REQUEST FOR COUNCIL ACTION

AGENDA SECTION: PUBLIC HEARINGS	ORIGINATING DEPT: PLANNING	ITEM NO. <i>E-5</i>
ITEM DESCRIPTION: <u>Land Subdivision Permit</u> (Preliminary Plat) #03-12 to be known as Wedgewood Hills Seventh by Leslie A. Lurken. The Applicant is proposing to subdivide approximately 13.63 acres of land into 49 lots for single family development and one Outlot. The Plat also proposes to dedicate new public roadways. The applicant is also requesting approval of a <u>Substantial Land Alteration</u> to permit site grading that will modify grades by more than 10 feet on portions of the property. The property is located south of 55 th Street NW and allows for the continuation of 51 st St. NW and Duvall St. NW.		PREPARED BY: Mitzi A. Baker, Senior Planner

The Department of Public Works has reviewed the application for PP#03-12, on the Wedgewood Hills Seventh property. The following are Public Works comments on the proposal from 4/10/03. New comments are shown in **BOLD**:

REVISED 05-12-03 PRELIMINARY PLAT #03-12

WEDGEWOOD HILLS SEVENTH

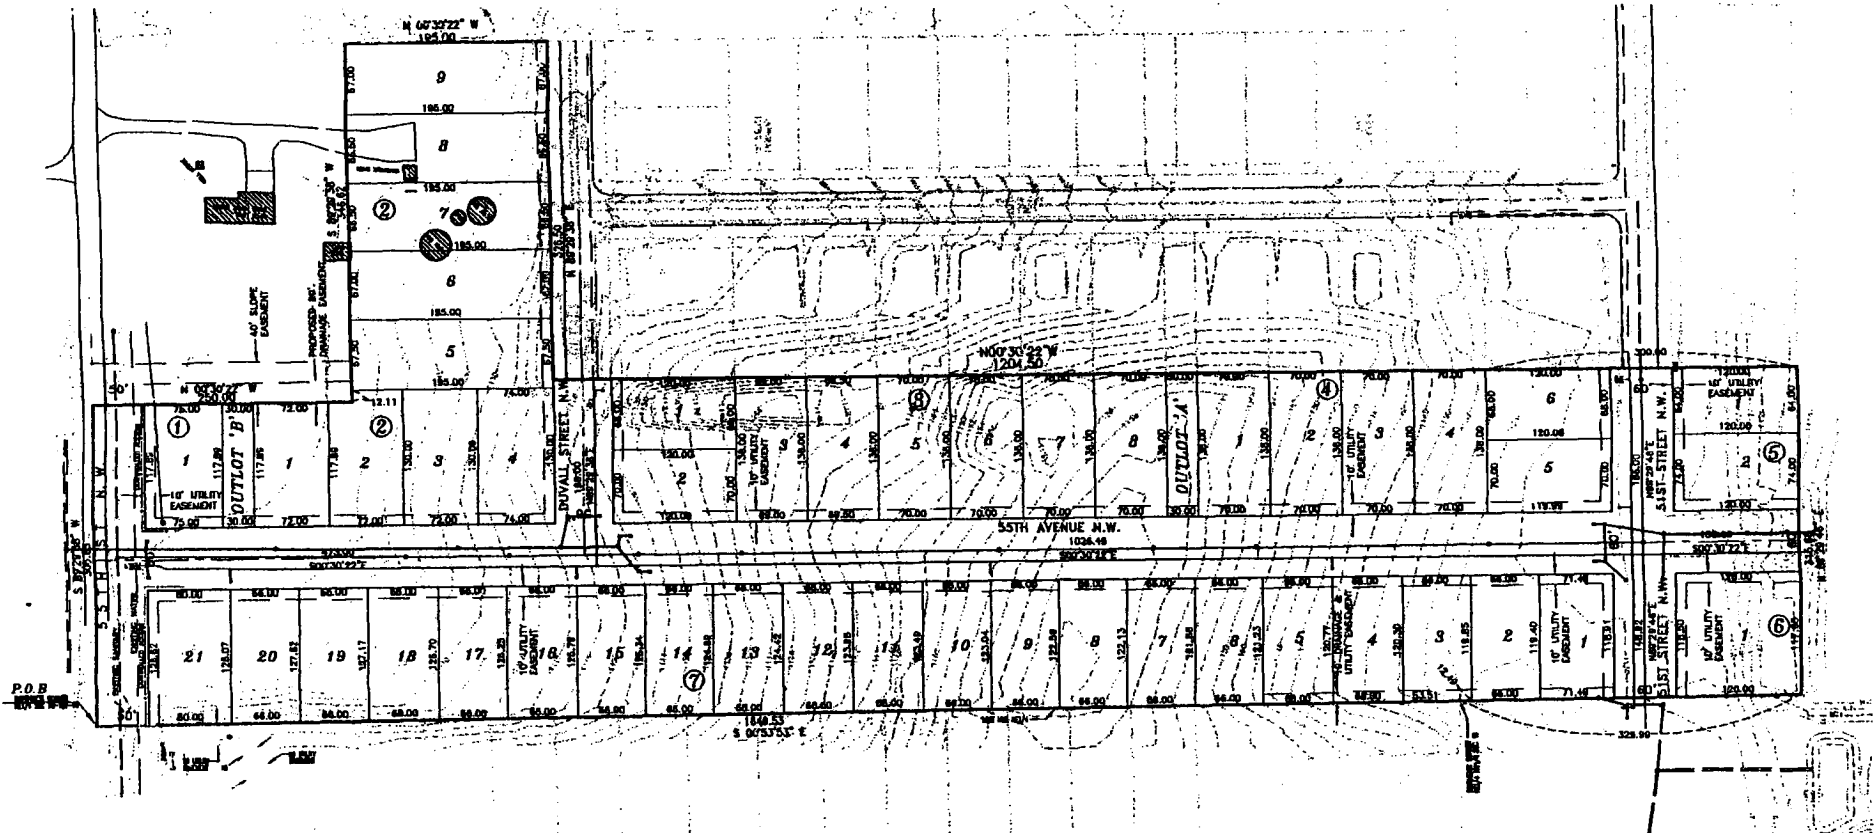
This Plat was Revised to identify Outlot B east of 55th Ave. NW, which will be constructed with a private road to facilitate future development/re-development of the farmstead parcel to the east. Based on the Revised Plat, staff recommends modifications to conditions, which are identified as underlined or strikethrough text.

1. *The Plat shall be revised to identify Access Control along the entire frontage of 55th St. NW except at the public road opening and also along both sides of 55th Ave. NW within 35 feet of the southerly right-of-way of 55th St. NW.*

9. *The applicant is responsible to construct a private roadway within Outlot B and must also extend utilities to serve the abutting exception parcel located north of Outlot B. An access easement shall be recorded over Outlot B for ingress/egress to the abutting parcel to the north (Krebsbach farmstead). The easement document must be recorded prior to recording the Final Plat and the Final Plat documents must be revised to identify the driveway easement and document number. The easement document shall be perpetual, establish a clear policy on how maintenance will be handled, establish the rights of usage, and define how use of the easement is limited or assignable. Public safety personnel and their vehicles shall be assigned the right of passage at all times.*

SUBSTANTIAL LAND ALTERATION EXHIBIT

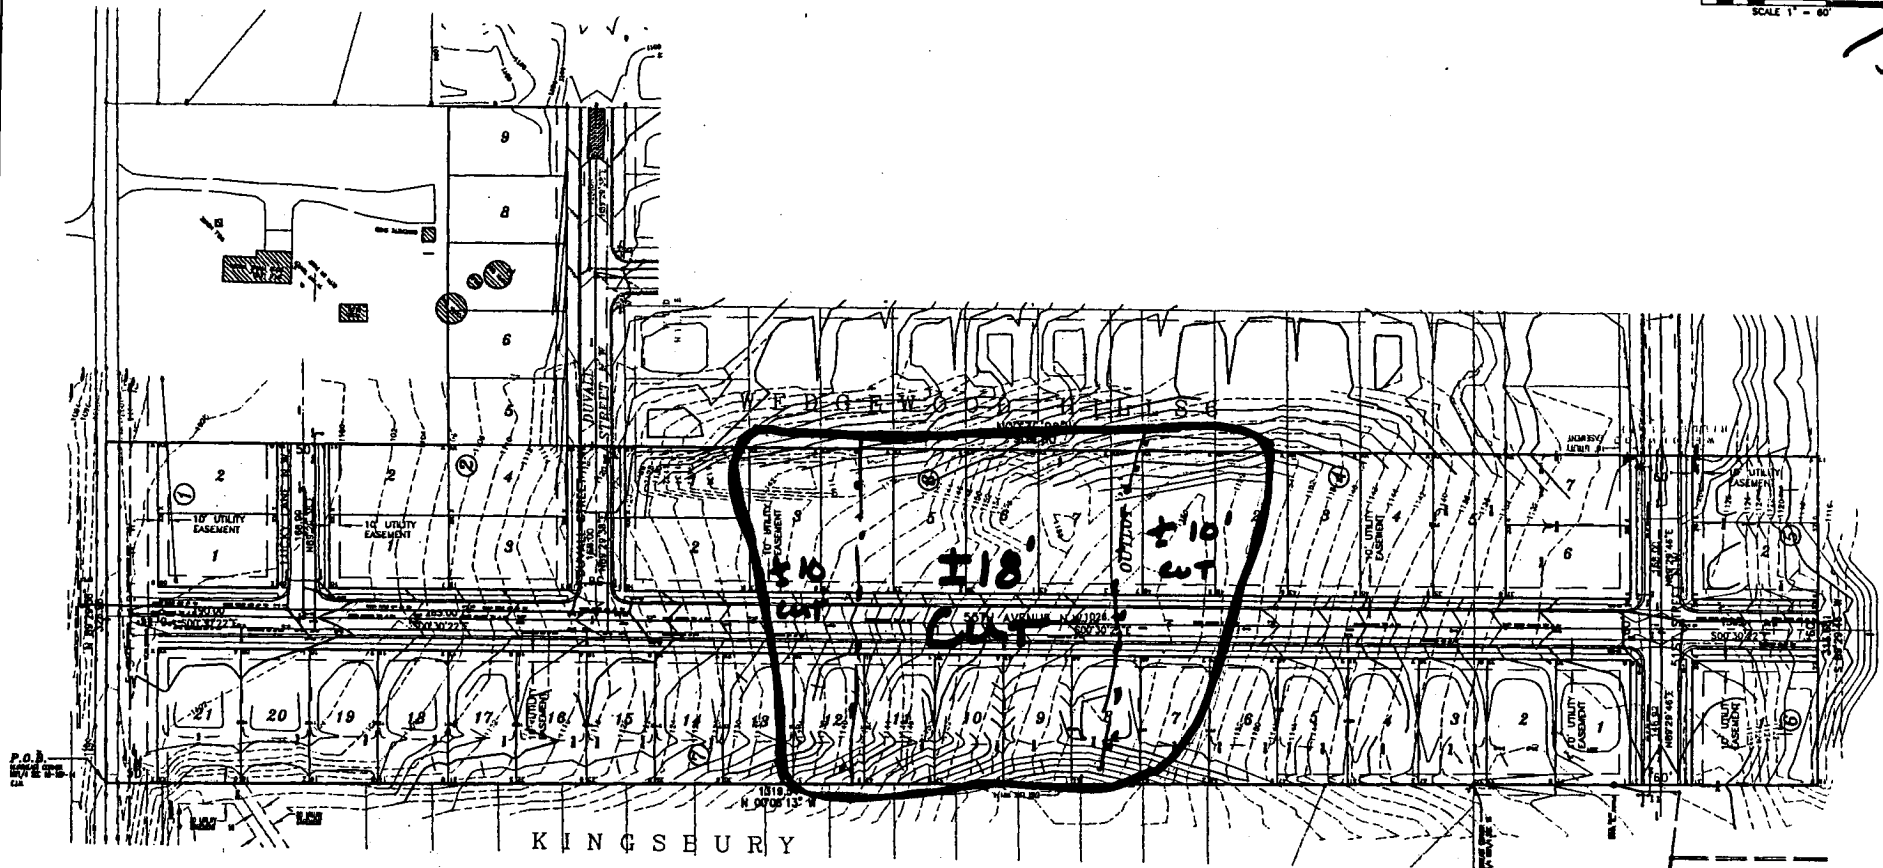
Section 62.1101 of the Rochester Land Development Manual and Zoning Ordinance contains new standards for substantial land alteration projects. The grading of the Wedgewood Hills Seventh site will result in exceeding a 10-foot vertical cut and a 10-foot vertical fill over various portions of the site. This project meets the definition of Section 62.1101.2.a.1(d) where the cut/fill involves a grade change of 10-feet or more from the pre-existing grades. The enclosed grading plan indicates the cut and fill areas on the site. The maximum extreme cut would be approximately 18', which will occur on the middle portion of the site. (See grading plan.)
